# THE GLEN AT WIDEFIELD FILING NO. 9

## RESIDENTIAL SUBDIVISION CONSTRUCTION DRAWINGS

**GLEN AT WIDEFIELD FILING NO. 9**  
**SPRING GLEN DRIVE (Sta. 30+00 to Sta. 43+00)**  
PLAN AND PROFILE  
EL PASO COUNTY, COLORADO

**GLEN AT WIDEFIELD FILING NO. 9  
STORM SEWER PLAN (Outfall & Offsite)  
PLAN AND PROFILE  
EL PASO COUNTY, COLORADO**

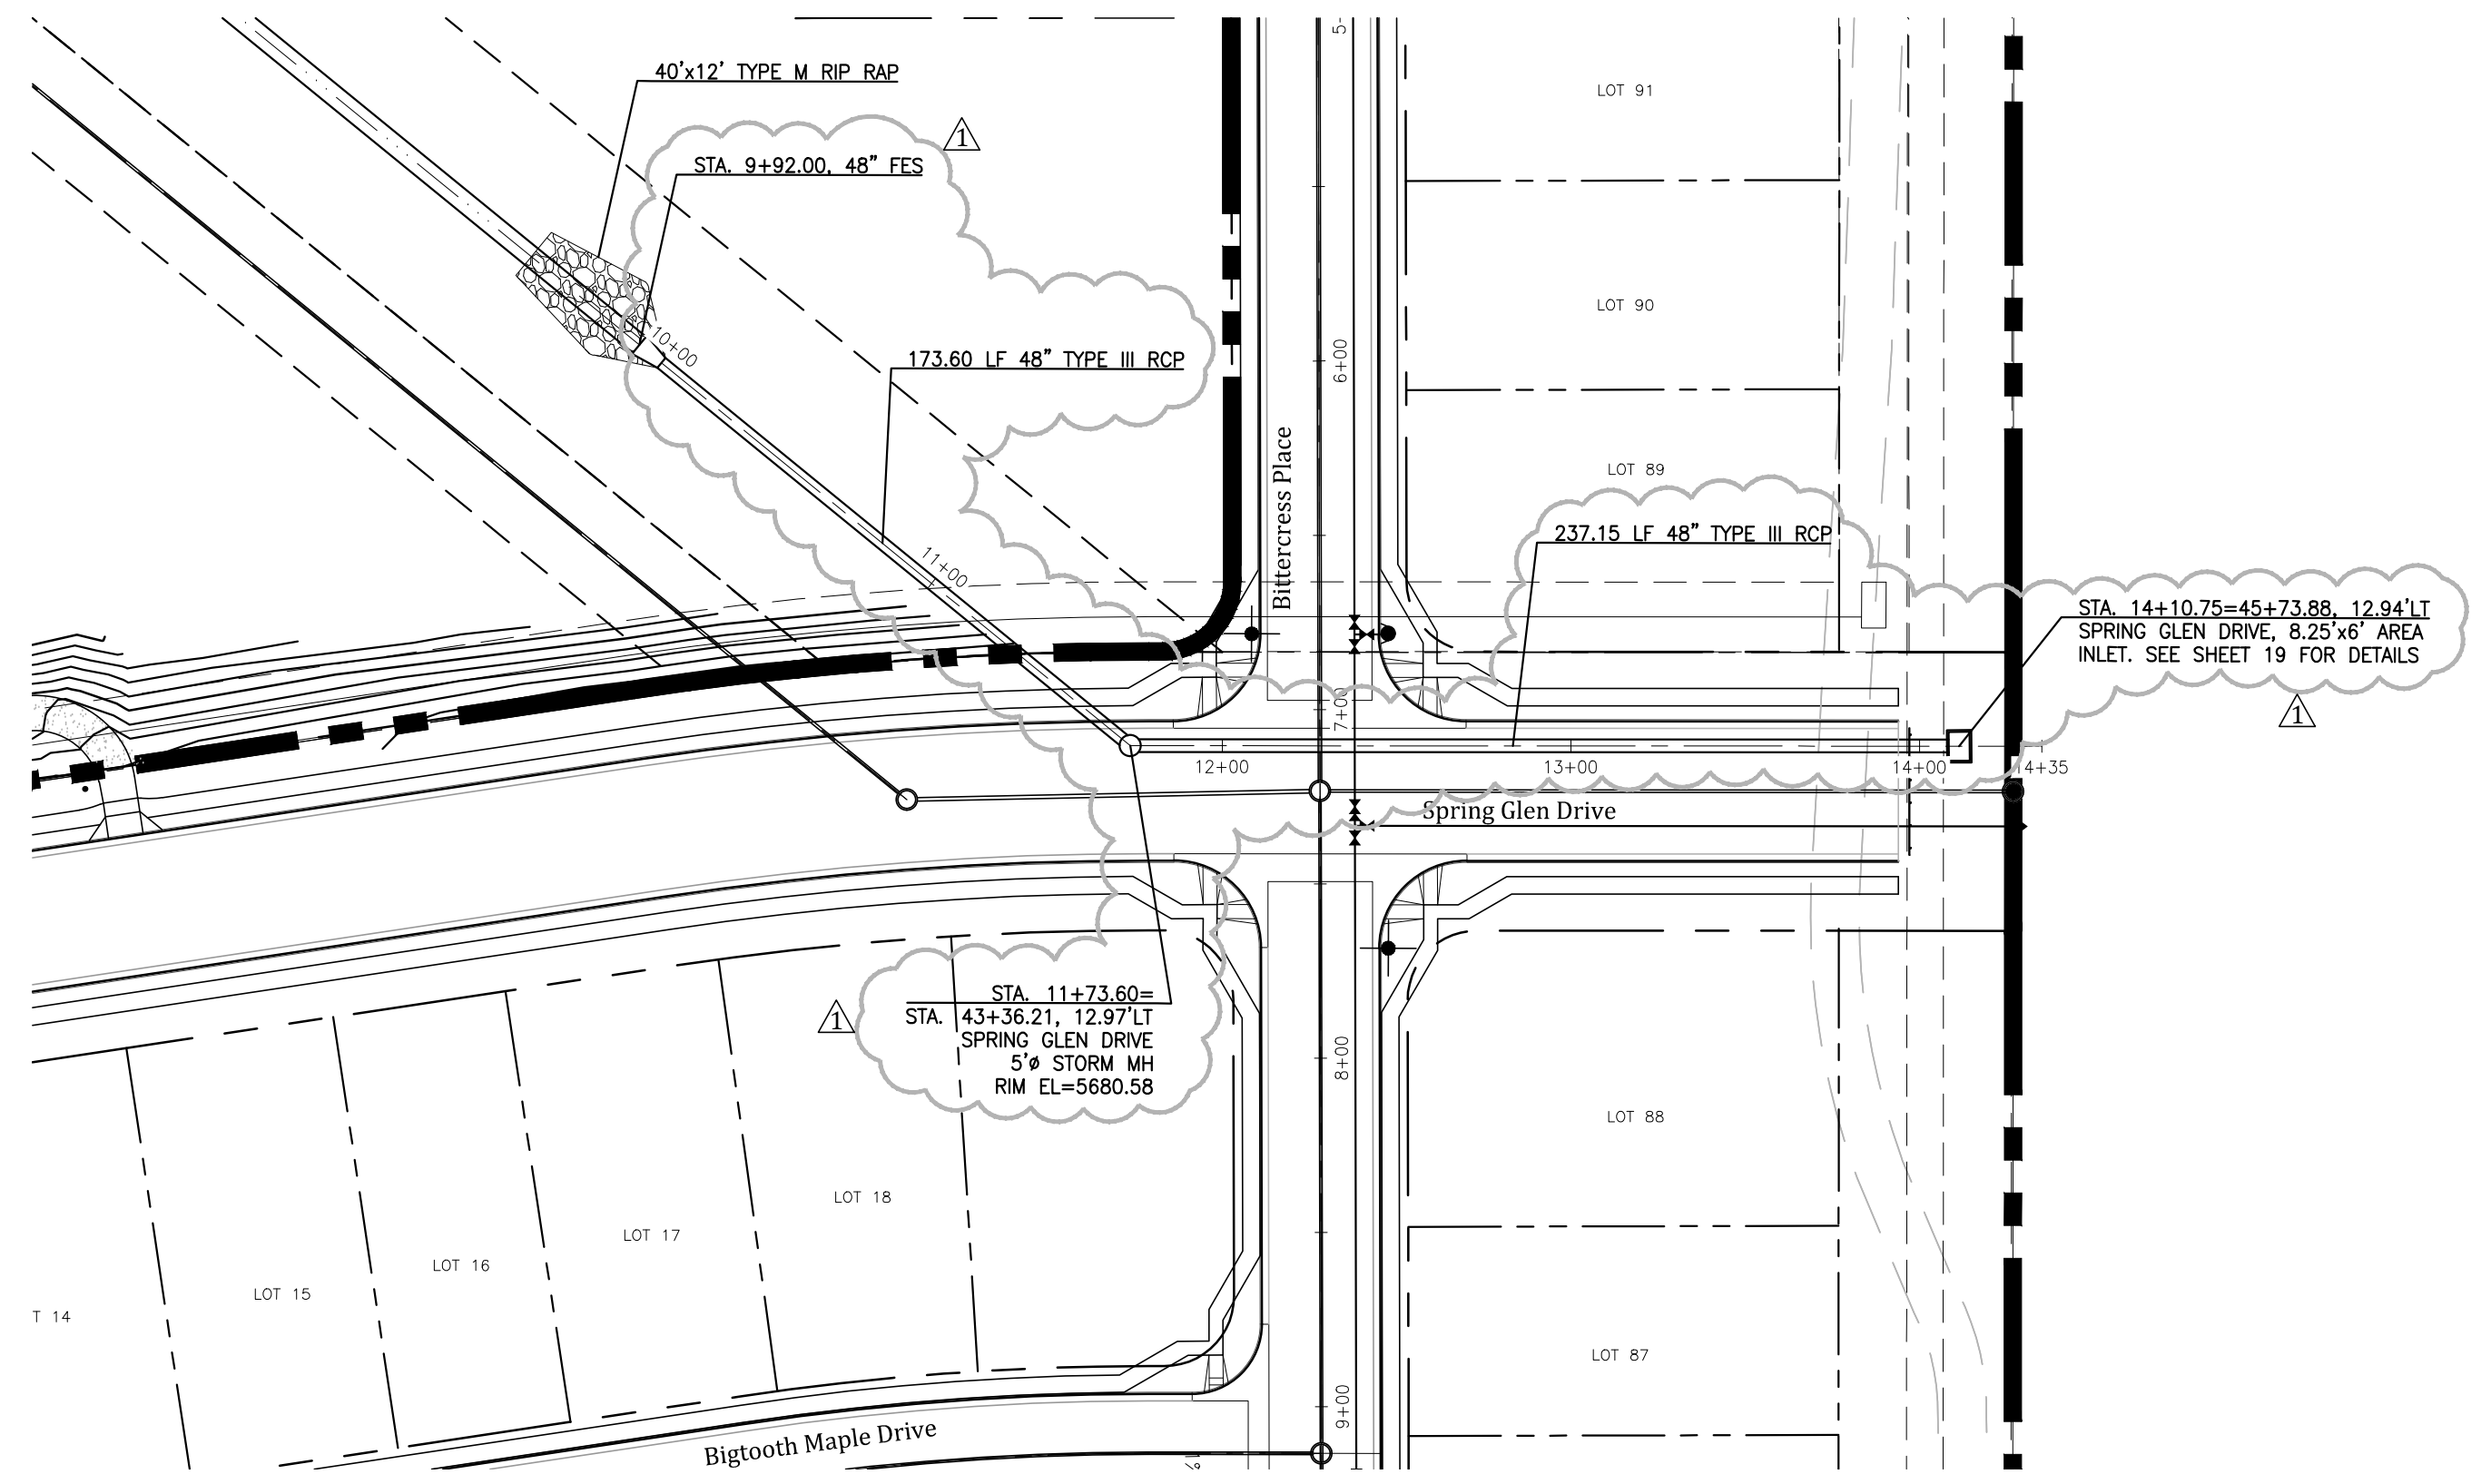
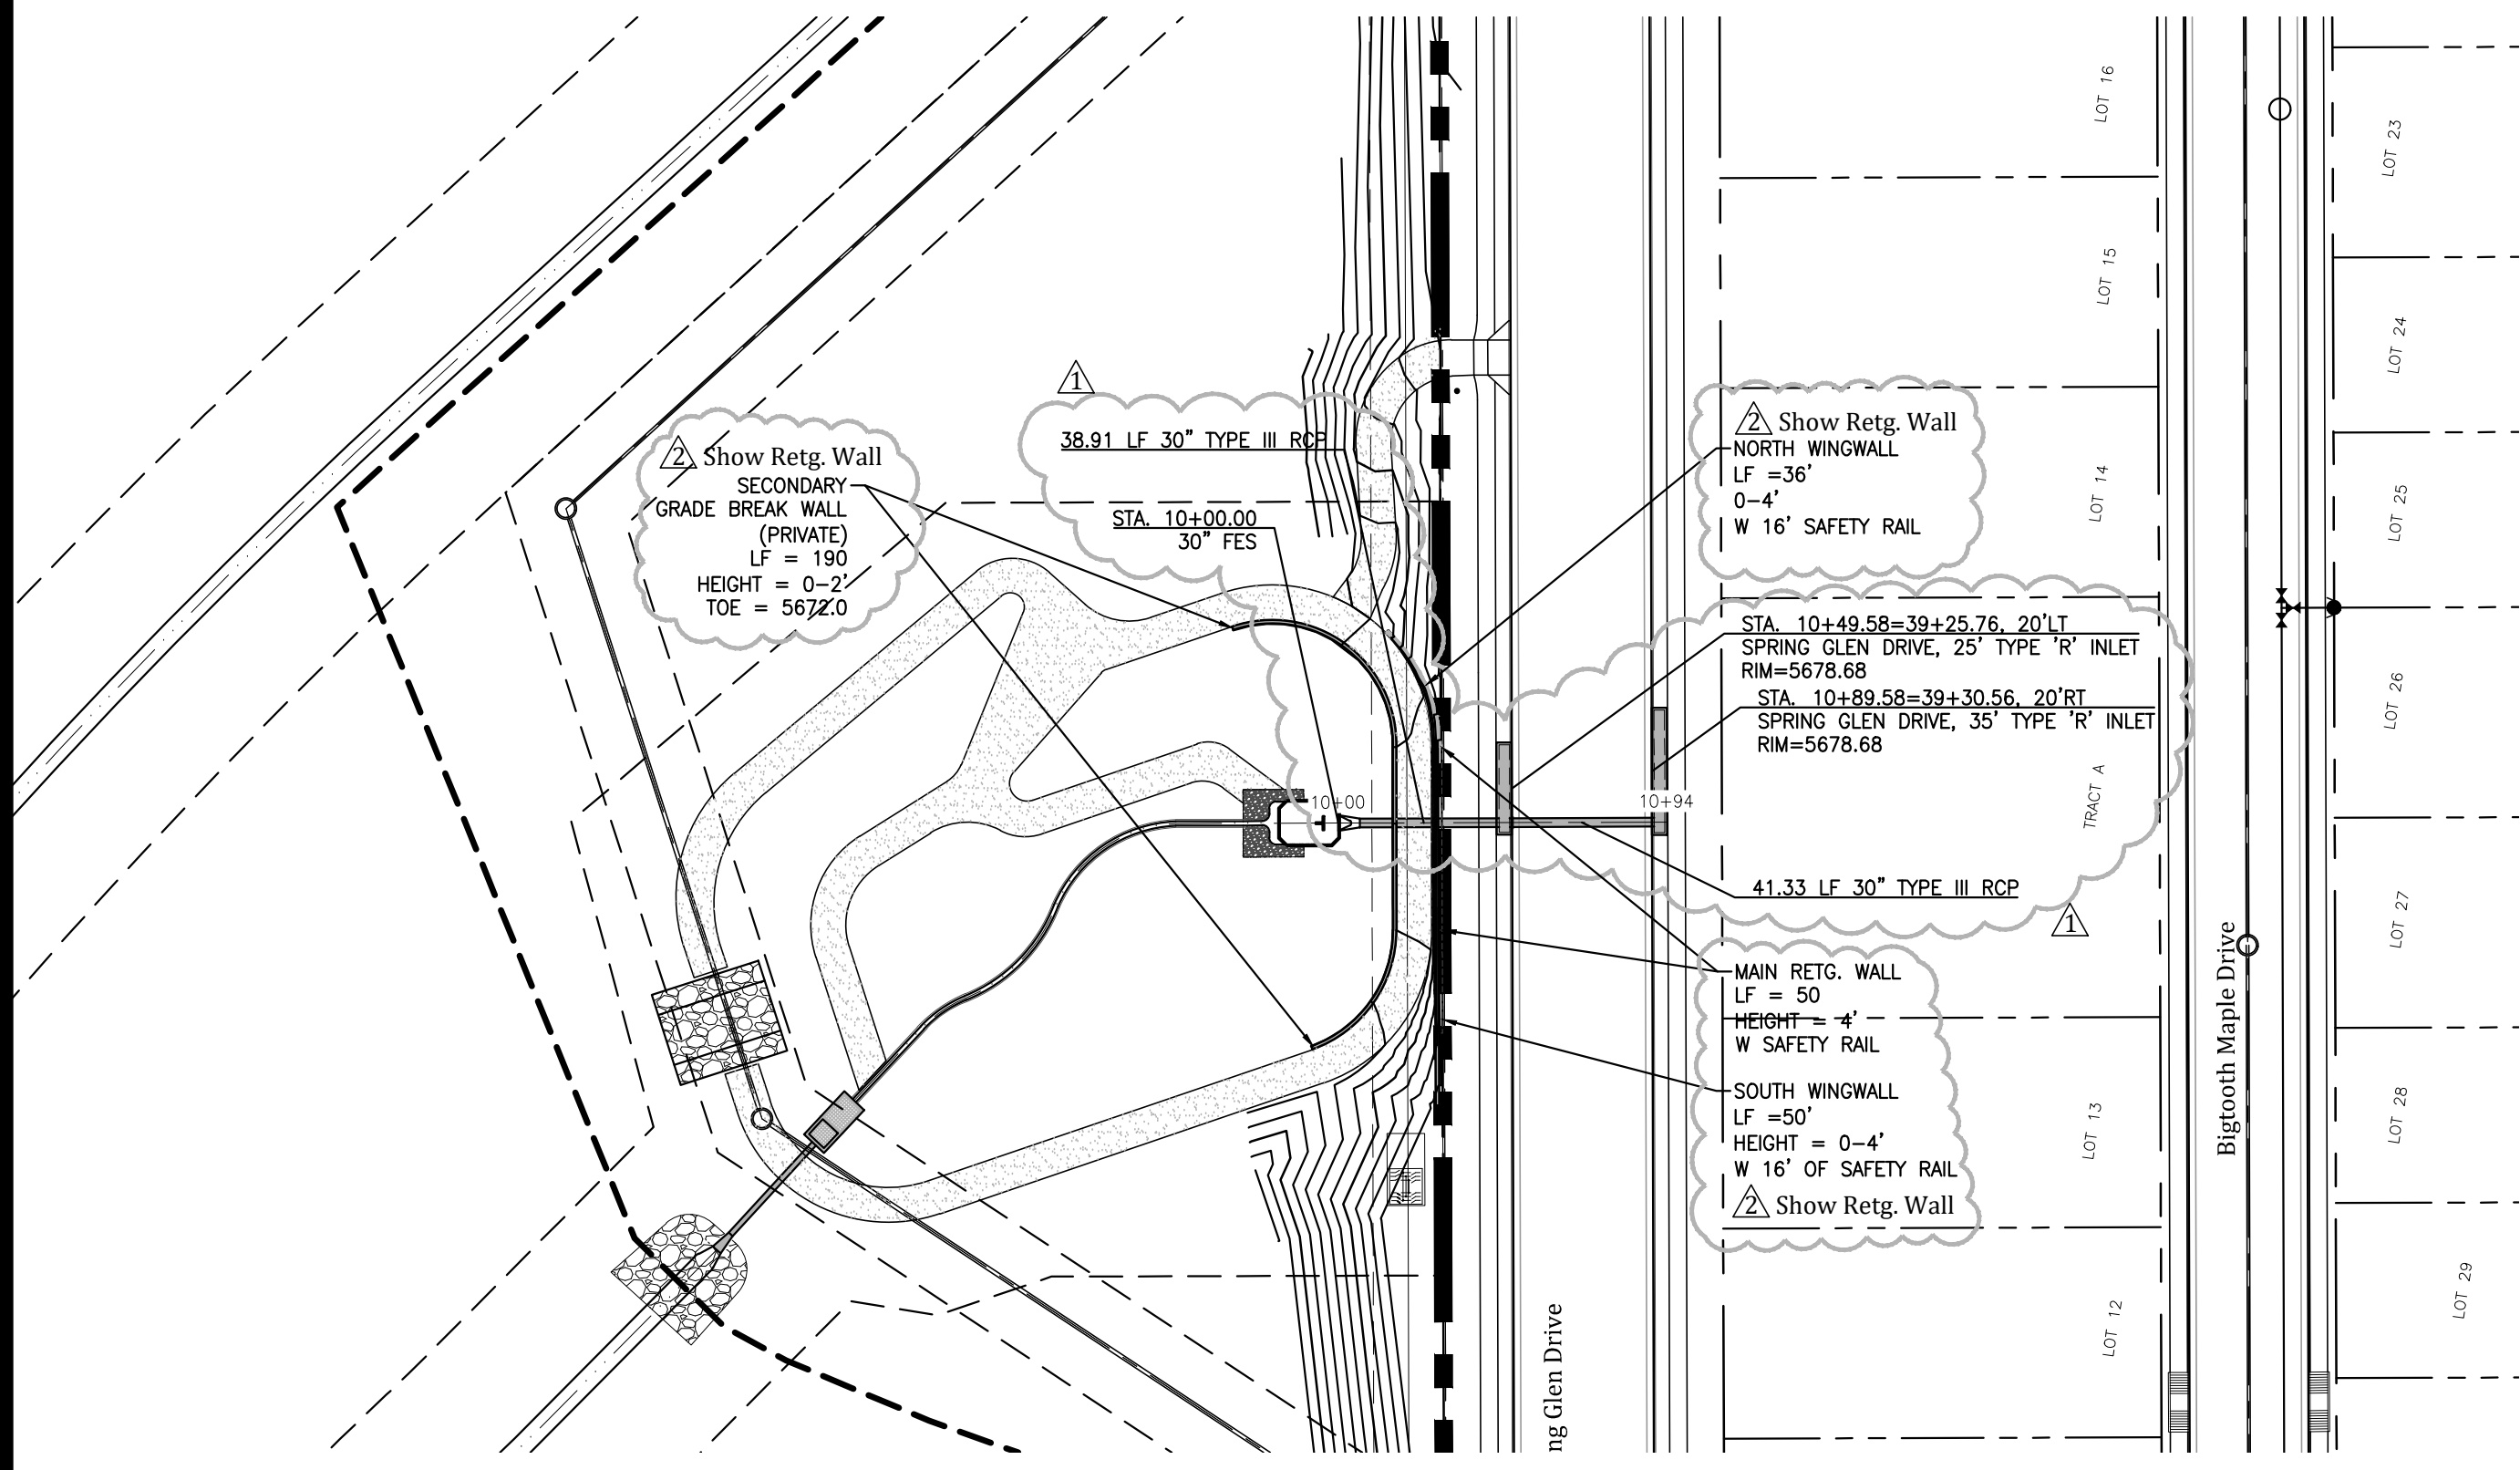
Show the ROW and provide a dimension label for the offset between the retaining wall and ROW.

Add note that no part of the retaining wall such as anchors shall be placed within the ROW.

Check with the water/sewer district if this is acceptable clearance or casing is required.
